NEDO–24011–A–14–US
July 2000

Licensing Topical Report

General Electric Standard Application for Reactor Fuel

(Supplement for United States)

Figure 5.2-1. Effects of Initial MCPR on DCPR Typical BWR Core

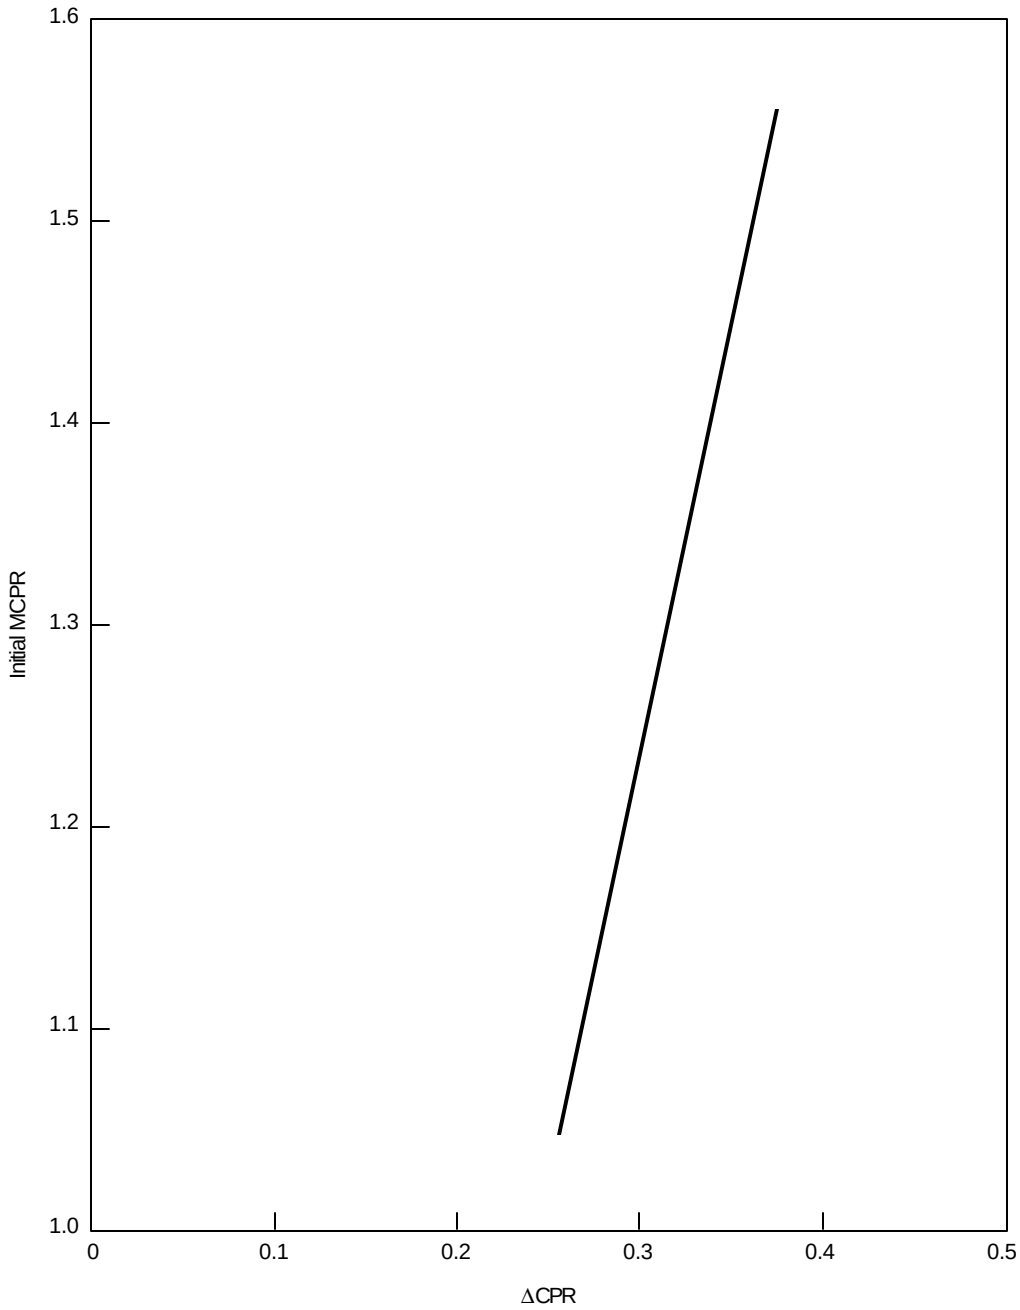
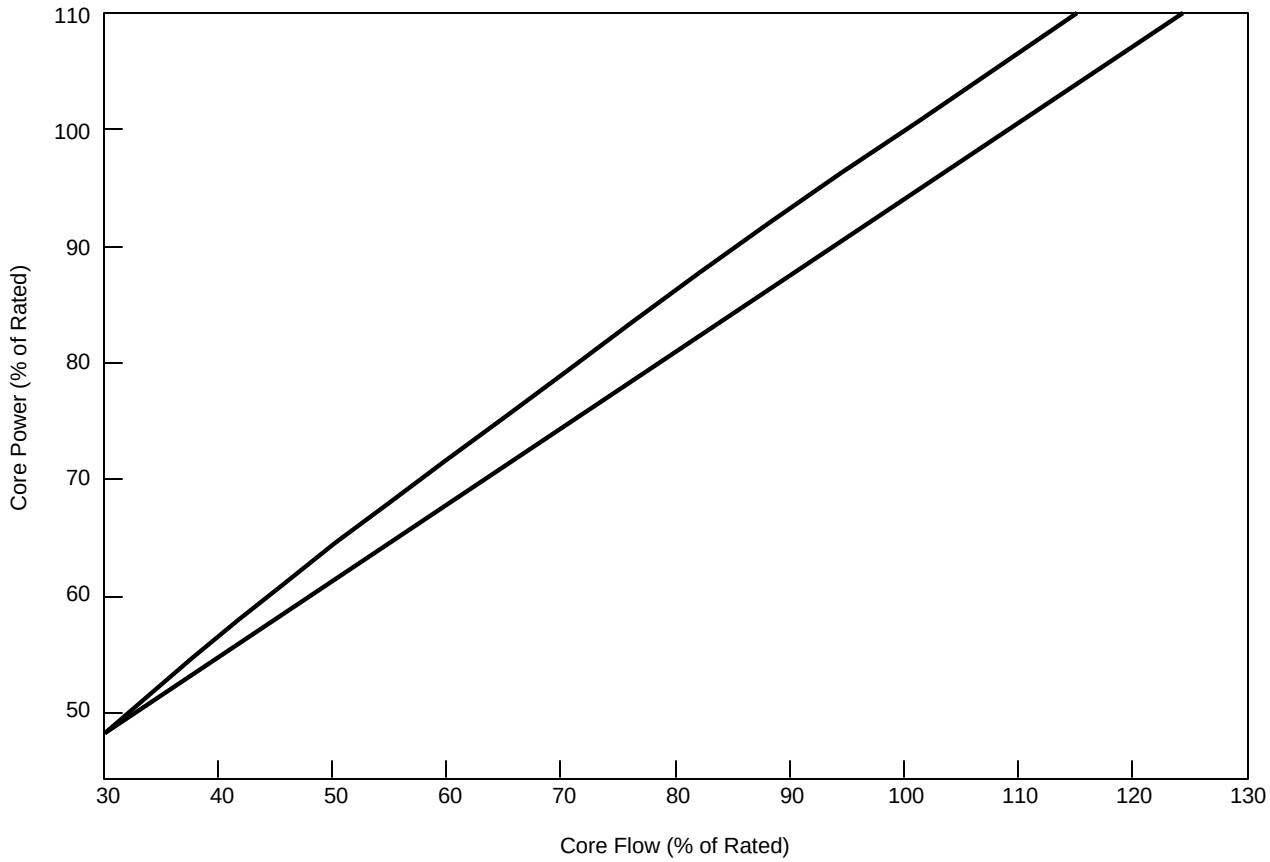
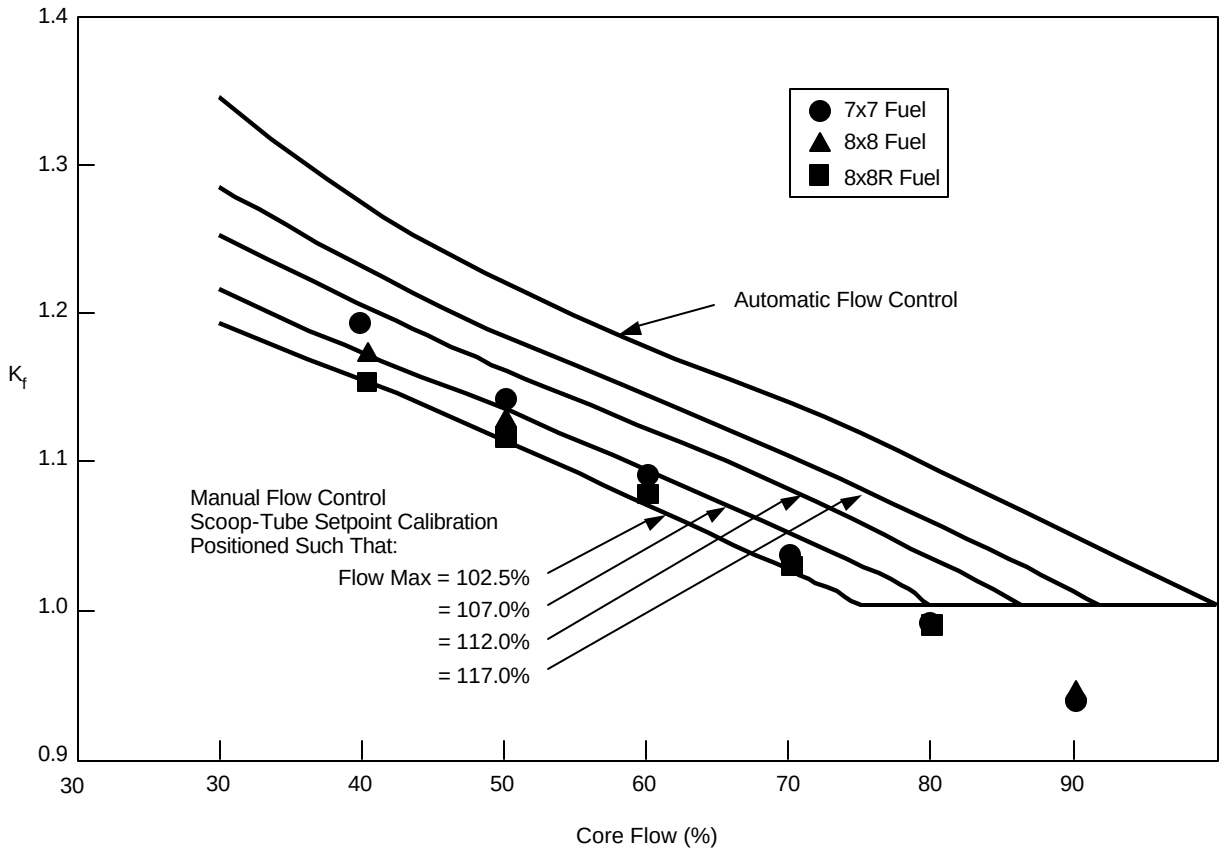
The brief paragraphs, which discuss the operating limit MCPR/low flow correction curves, K_f, for reduced core flow conditions, do not adequately describe the basis for the construction of the generic curves shown in Figure 5-7. A substantially more detailed discussion of the procedure employed is required. Describe the models, methods and assumptions used, which make the curves generic for BWR/2, BWR/3 and BWR/4 plants incorporating up to three different fuel designs. Either justify why the new fuel design (8x8R) is conservatively bounded by the analysis or provide an additional thermal hydraulic analysis to demonstrate that the indicated curves are bounding. Clearly state the criteria used for developing the curves for the automatic and manual flow control modes.

The pressure ordinate values in Figure 5-8 appear to be incorrect as shown. Please correct. The units and ordinate values for the peak surface heat flux, on the same figure, appear to be inconsistent. Please correct.

The initial MCPR assumed for transient analyses is usually greater than or equal to the GETAB operating limit. The attached Figure 5.2-1 illustrates the effect of the initial MCPR on transient ΔCPR for a typical BWR core. This figure indicates that the change in DCPR is 0.01 for a 0.05 change in initial MCPR. Therefore, in some cases, nonlimiting GETAB transient analyses may be initiated from a MCPR below the operating limit because the higher operating limit MCPR more than offsets the increase in ΔCPR for the event. This may also be applied to limiting transients if the difference between the operating limit and the initial MCPR is small (0.01 or 0.02).

The power-flow relations used in this example are provided in Figure 5.2 2. Pertinent core parameters are:

Note that as a particular plant's operating limit MCPR increases above 1.20, the K_f curves (Figure 5-7) will become increasingly conservative (i.e., if the operating limit was to increase for a given reload 1.20 to 1.30, the curves would be overly conservative by the ratio 1.30/1.20, because the change in critical power ratio with core flow should not change from cycle to cycle). This "overconservatism" is presently being reviewed and future changes to the K_f approach are being considered.

Figure 5.2-3 compares the derived 102.5% core flow K_f curve with the standard curves (Figure 5-7). These results show that the 8x8R fuel closely follows the 102.5% line, but the 7x7 fuel is 3.3% nonconservative at 40% core flow. However, the K_f curves are conservative for all cores with 7x7 operating limits greater than 1.23.

Figure 5.3-1. Effect of Scram Time on Peak Vessel Pressure

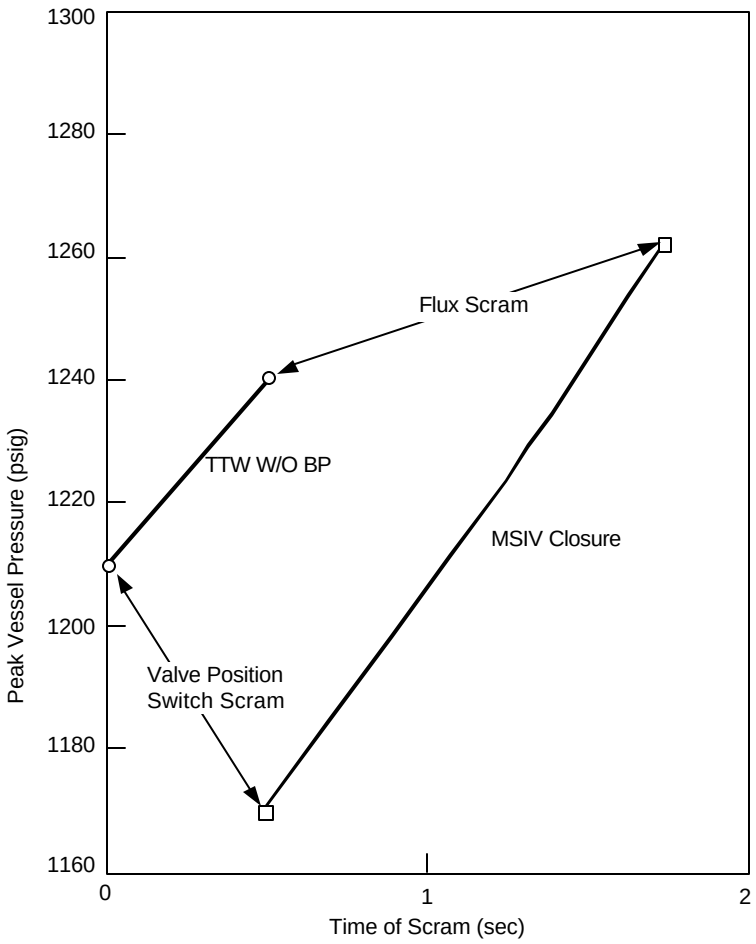
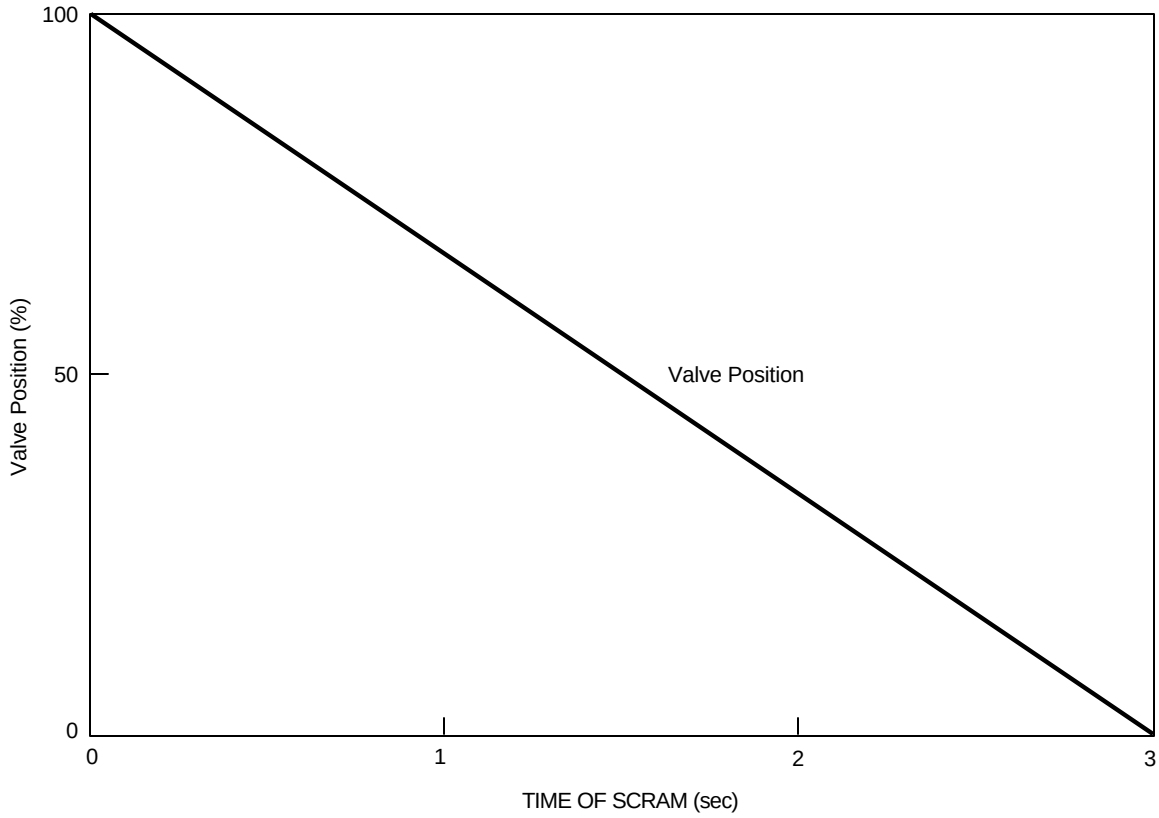
REQUEST: Subsection 5.3 – ASME Code Compliance for Vessel Pressure

The MSIV closure event has been demonstrated in the past to be more severe than the turbine or generator trip without bypass when credit is not taken for direct scram. An illustration of the typical relationship between these events is shown in Figure 5.3-1 (attached). Limiting events which are affected by a scram trip are generally most limiting at the end of the cycle due to the dominating effect of the scram degradation in this portion of the cycle because the control blades are withdrawn from the core.

The power levels indicated in Table 5-6 are consistent with the power levels given in plant technical specifications and used as the basis for the safety analysis. The General Electric basis for code overpressure protection analysis has been documented in Reference 5-14. As noted in the response to the request on Subsection 5.2.1, GE specifically addressed the 2% adder to the initial power, to all transient analysis in Reference 1. Figure 5.3-2 shows the assumed closure rate used in this analysis.
